SHEARON HARRIS NUCLEAR POWER PLANT, UNIT 1  
DOCKET NO. 50-400/RENEWED LICENSE NO. NPF-63  
SUPPLEMENT TO MEASUREMENT UNCERTAINTY  
RECAPTURE POWER UPRATE LICENSE AMENDMENT REQUEST

SHEARON HARRIS NUCLEAR POWER PLANT, UNIT NO.1  
DOCKET NO. 50-400/RENEWED LICENSE NO. NPF-63  
REQUEST FOR LICENSE AMENDMENT  
EVALUATION OF PROPOSED CHANGES

Subject: *Request for License Amendment to revise Renewed Operating License NPF-63, Technical Specifications, and associated Technical Specification Bases to reflect the uprated reactor core power level.*

FIGURE 2.1-1  
REACTOR CORE SAFETY LIMITS - THREE LOOPS IN OPERATION  
WITH MEASURED RCS FLOW > [293,540 GPM X (1.0 + C<sub>1</sub>)]

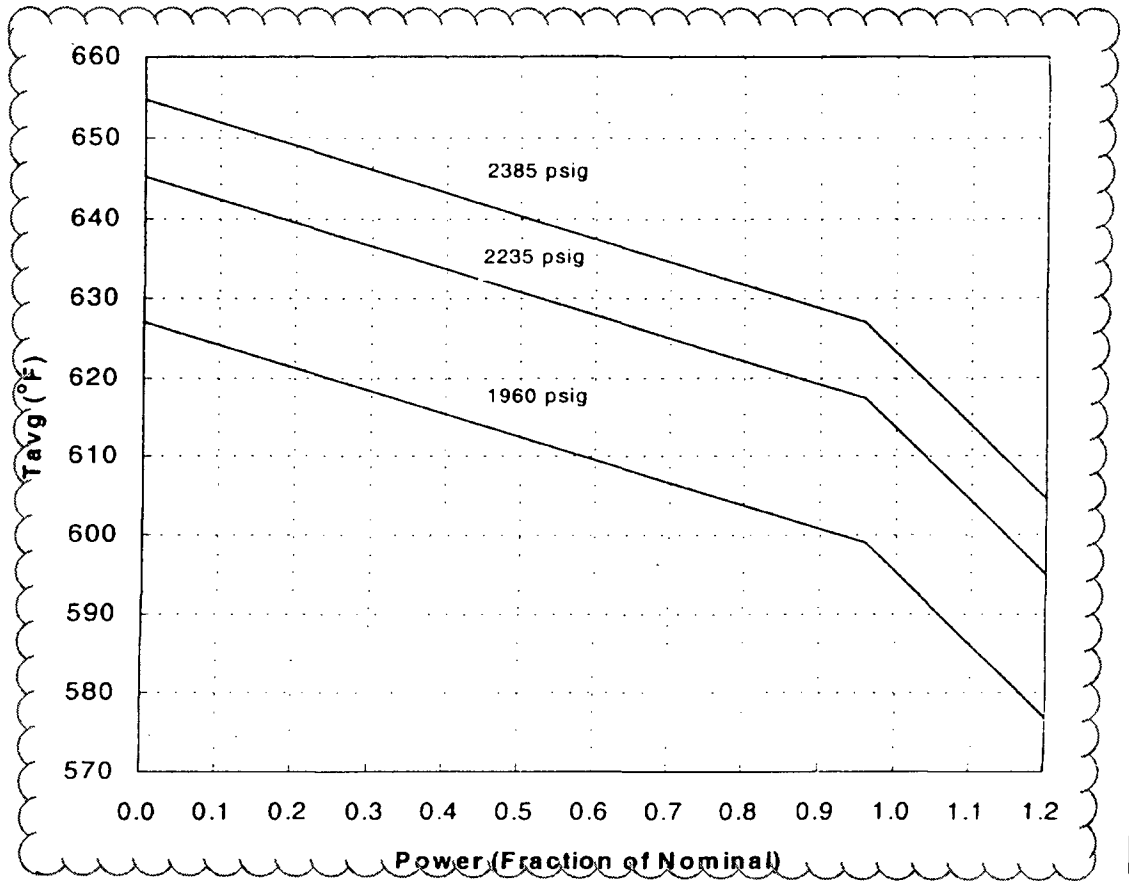
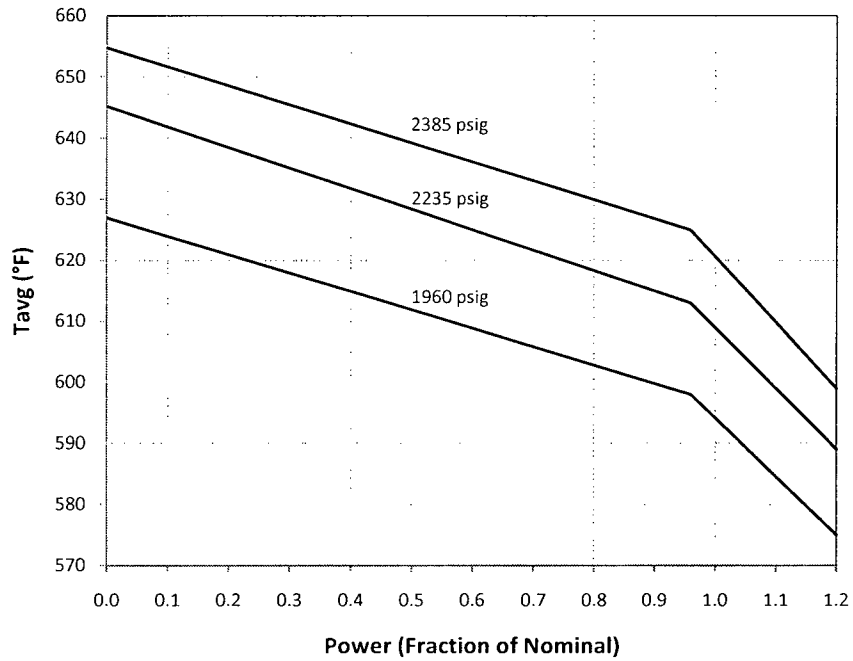
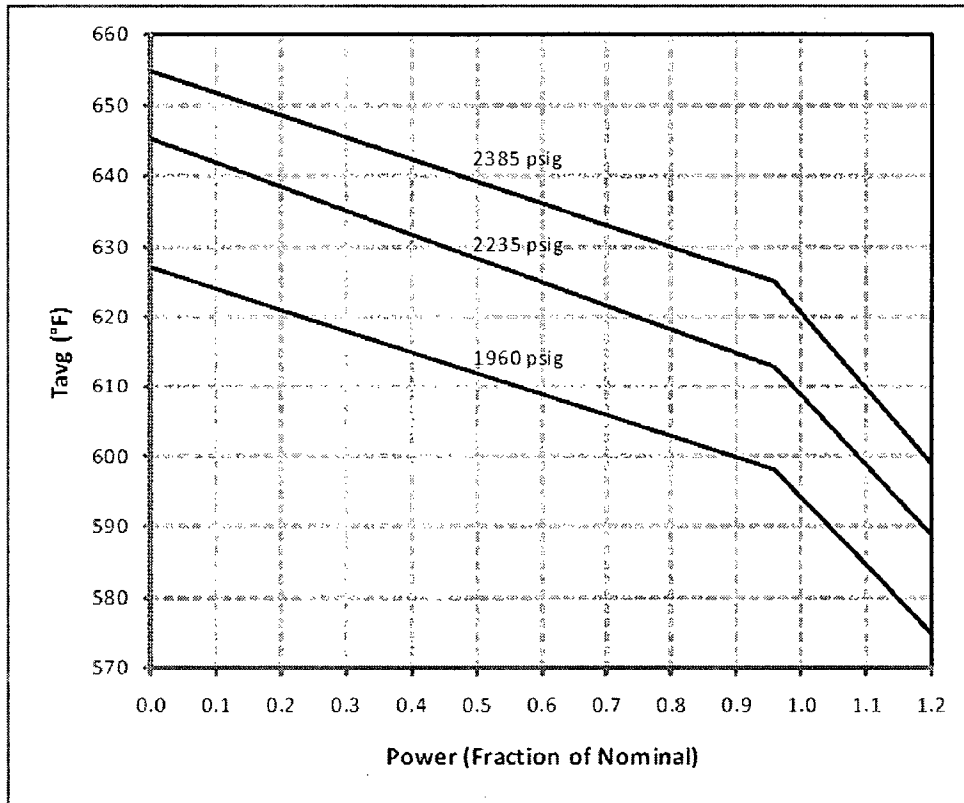
Change No.	Change Description
3	<p><b>TS Figure 2.1-1: Reactor Core Safety Limits - Three Loops in Operation with Measured RCS Flow &gt; [293,540 GPM X(1.0 + C<sub>1</sub>)]</b>                      Core Safety Limit lines are redrawn on this figure.</p>
4	<p><b>TS Table 2.2-1: Reactor Trip System Instrumentation Trip Setpoints</b>                      The Total Allowance (TA) column is revised for the PR Neutron Flux - High setpoint (5.83) and Low setpoint (7.83), and the PR Neutron Flux - High Positive Rate (2.33) and High Negative Rate (2.33).</p> <p><b>TS Table 2.2-1: Reactor Trip System Instrumentation Trip Setpoints</b>                      The PR Neutron Flux - High Trip setpoint is revised to <math>\leq 108\%</math>.</p> <p><b>TS Table 2.2-1: Reactor Trip System Instrumentation Trip Setpoints</b>                      The Allowable Value column is revised for the PR Neutron Flux - High setpoint (<math>\leq 109.5\%</math>) and PR Neutron Flux - Low setpoint (<math>\leq 26.8\%</math>).</p>

2.2 TS Figure 2.1-1: Reactor Core Safety Limits - Three Loops in Operation with Measured RCS Flow > [293,540 GPM X (1.0 + C<sub>1</sub>)]

The core safety limit lines are redrawn as indicated on the TS retyped pages (Attachment 2). The power uprate impact on the core thermal hydraulic design was evaluated for Final Safety Analysis Report (FSAR) Chapter 15 transients with regard to DNB and core safety limits. A statistical evaluation of the core safety limit lines using the currently approved methods and codes took into account the higher nominal power, reduced uncertainty, and design axial shapes at uprate conditions. The evaluation concluded that the existing core safety limit lines should be modified for consistency with the plant setpoints evaluation. The revised core safety limit lines data points are shown in Table 2 below.

Replace with  
INSERT A

**INSERT A:**
